DSO9404A-04

S E R V I C E N O T ESupersedes:
None**DSO9404A Oscilloscope: 4 GHz, 4 analog channels**

The 9000 series Infiniium scopes are showing intermittent shutdown symptoms. This service note is providing more information that Service Note - 02A doesn't always complete the repair. This Modification Recommended is to be done on any 9000 scope that is having the cover removed for any reason, and falls into the above serial number range.

Figure #1.

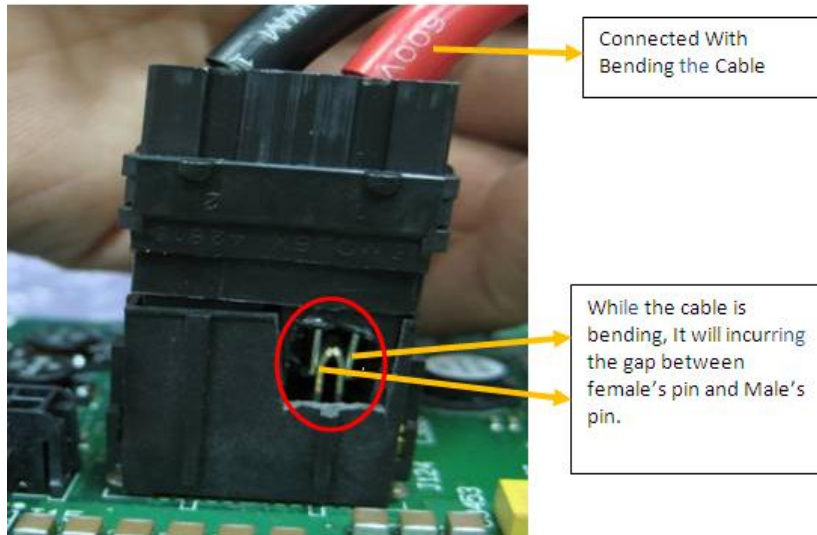
Many customers are experiencing Random Shutdowns. This make them want to have Service Note - 02A completed. The problem is with service note -02A, this isn't the only possible cause for the symptom consequently not resolving their problems. This issue has been determined to be a connection problem with the J124 connector on the acquisition assembly and the 12 volt power cable. See figure #1.

Replace the 12 Volt Bulk power cable to the longer version 54904-61631 eliminating the connector tilt increasing the surface tension. See Figure #2. Clean and inspect the connection J124 on the acquisition board. If the J124 is pitted then replace the acquisition board. Use contact cleaner or alcohol.
